**APPROVED**

Limited building only review  
Permit holder responsible for  
full compliance with the code

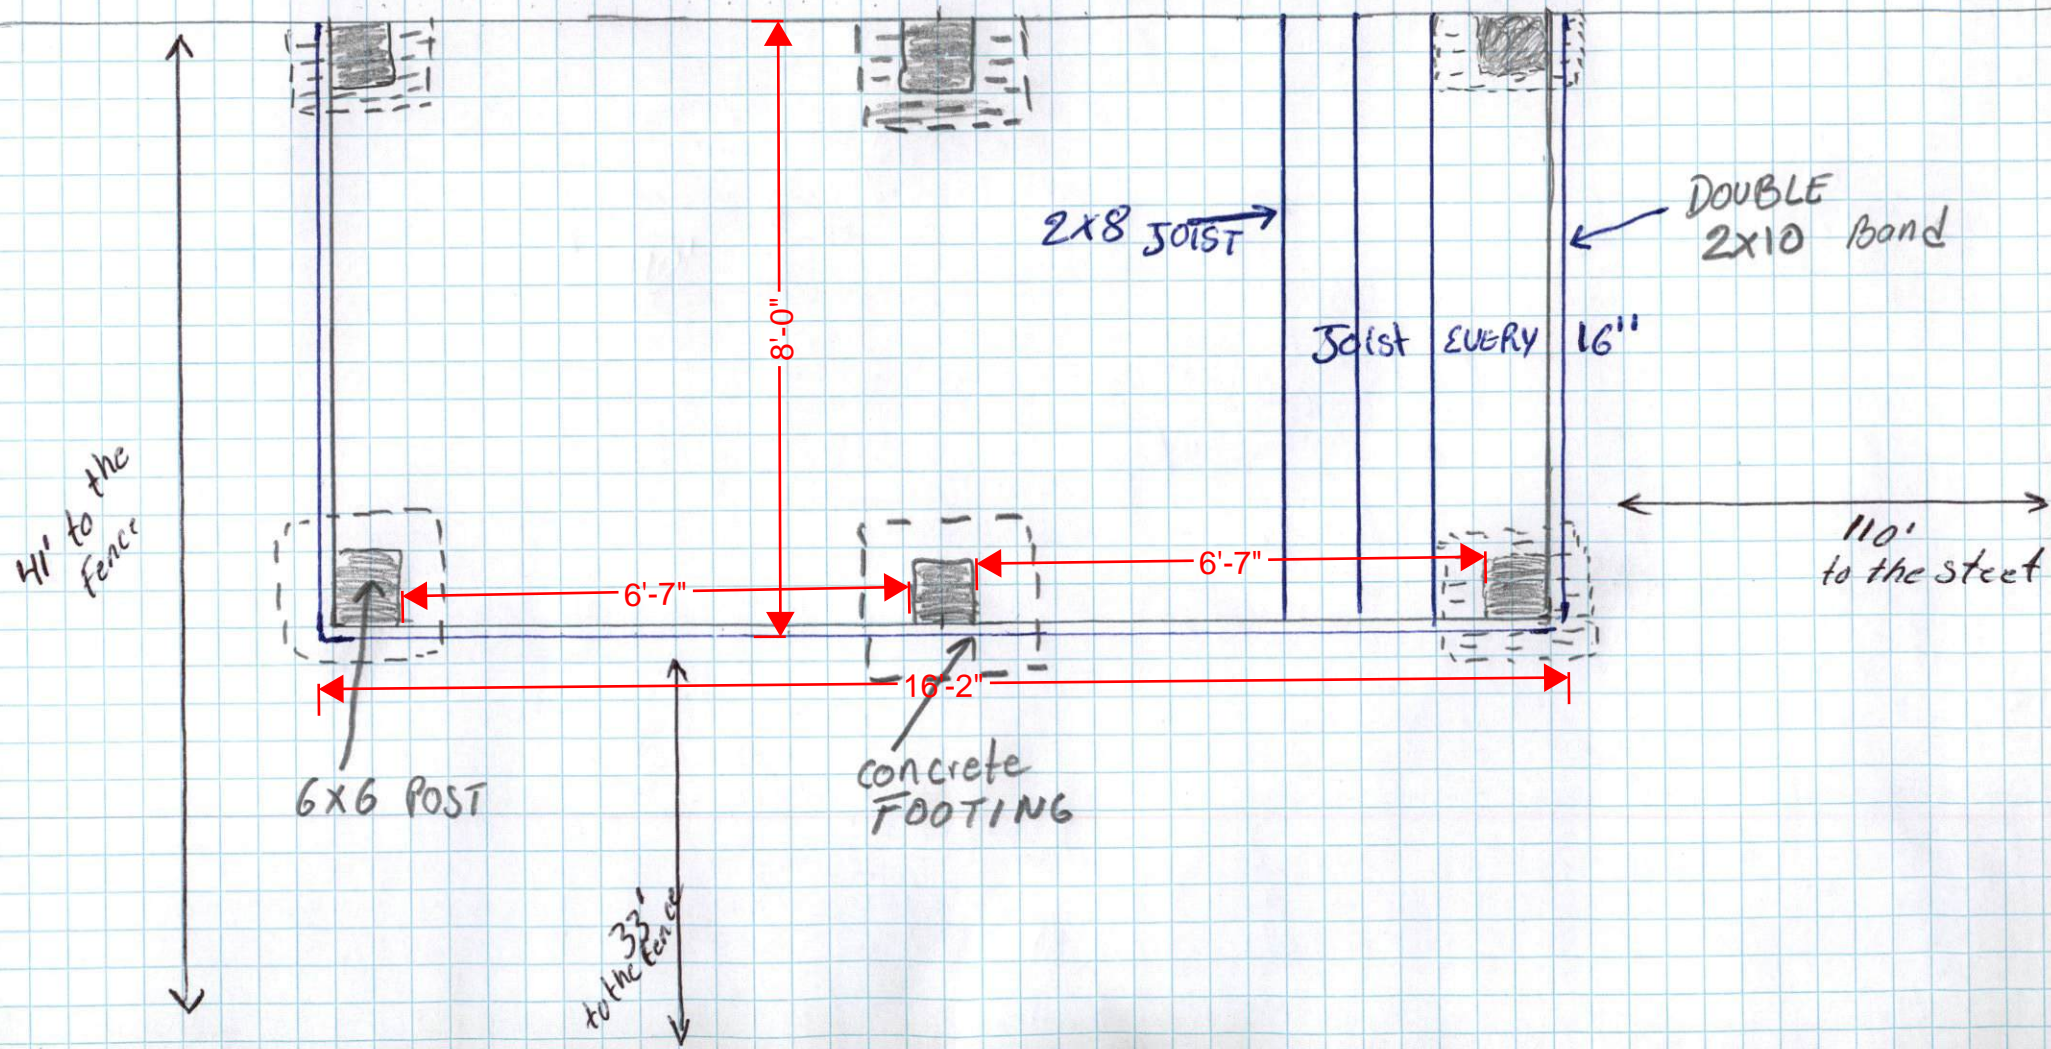
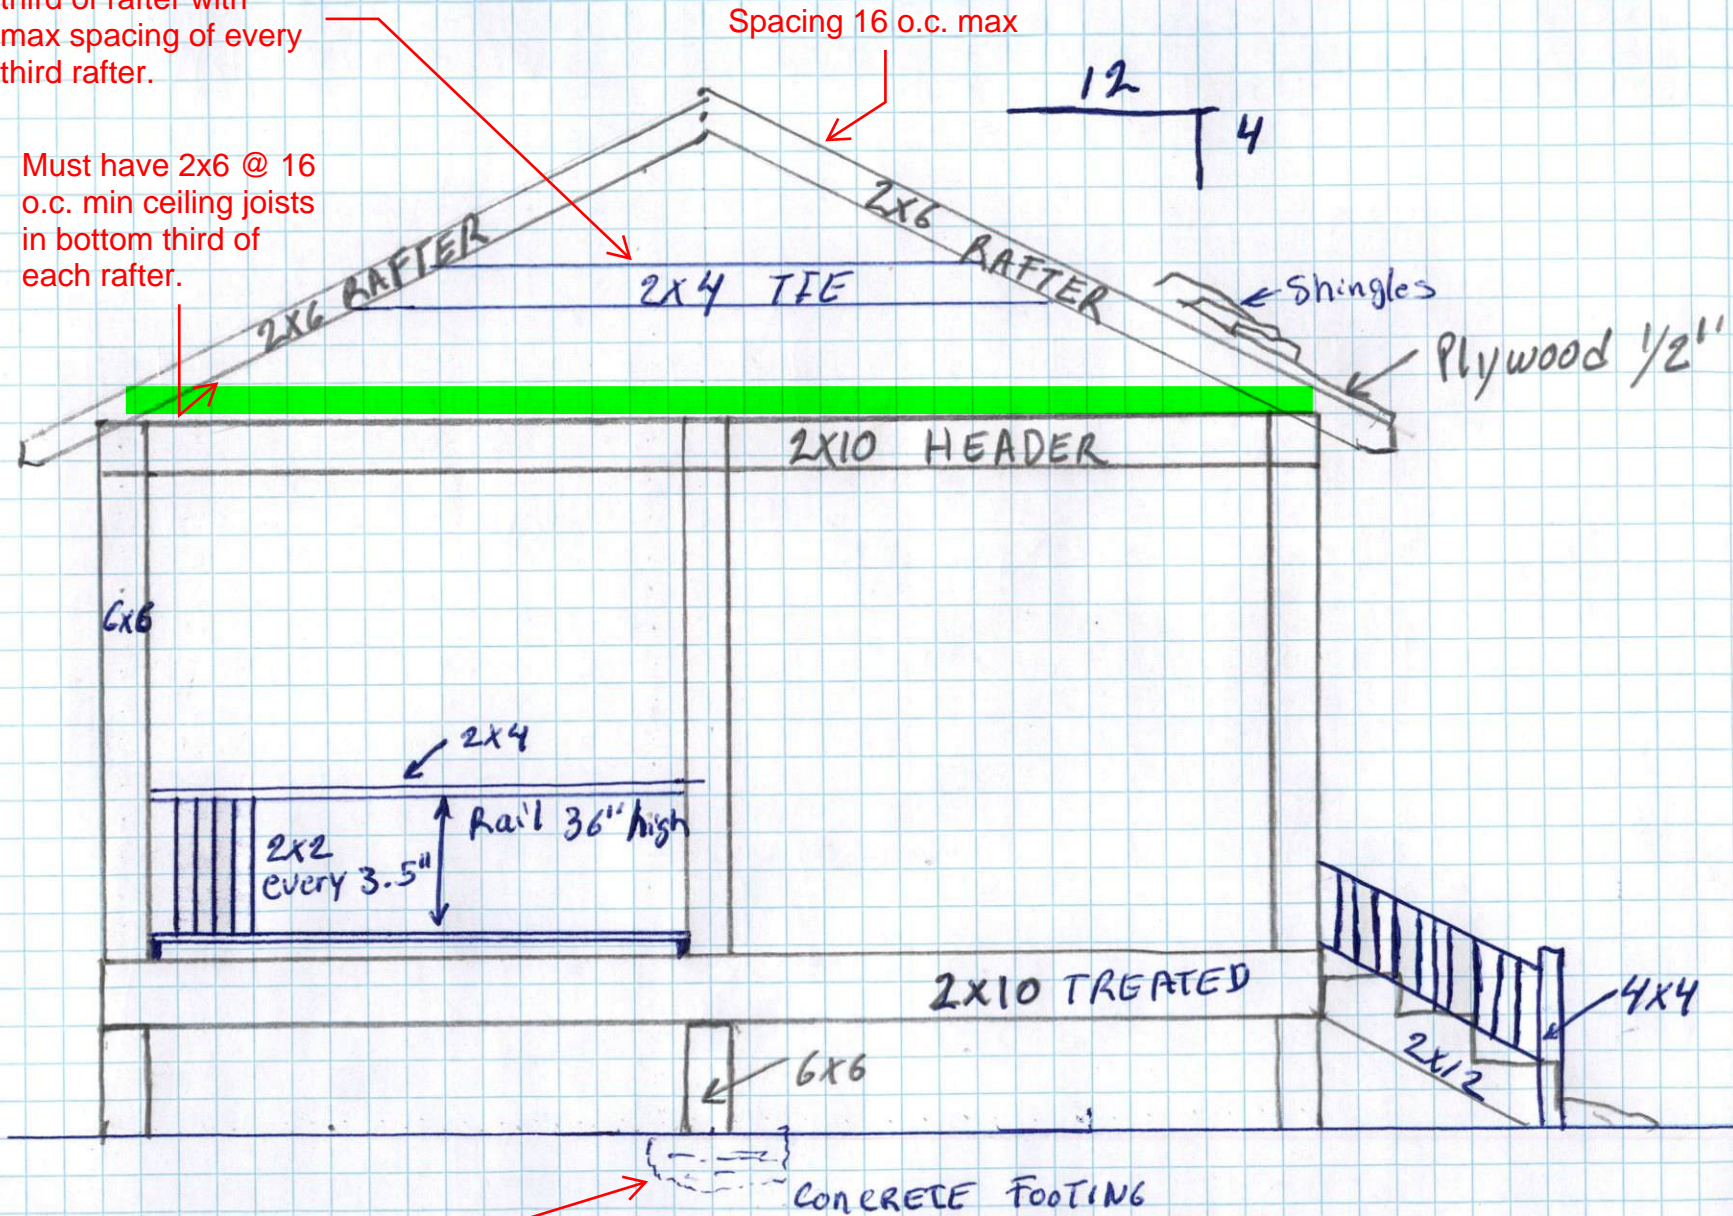
Ties must be in upper third of rafter with max spacing of every third rafter.

Must have 2x6 @ 16 o.c. min ceiling joists in bottom third of each rafter.
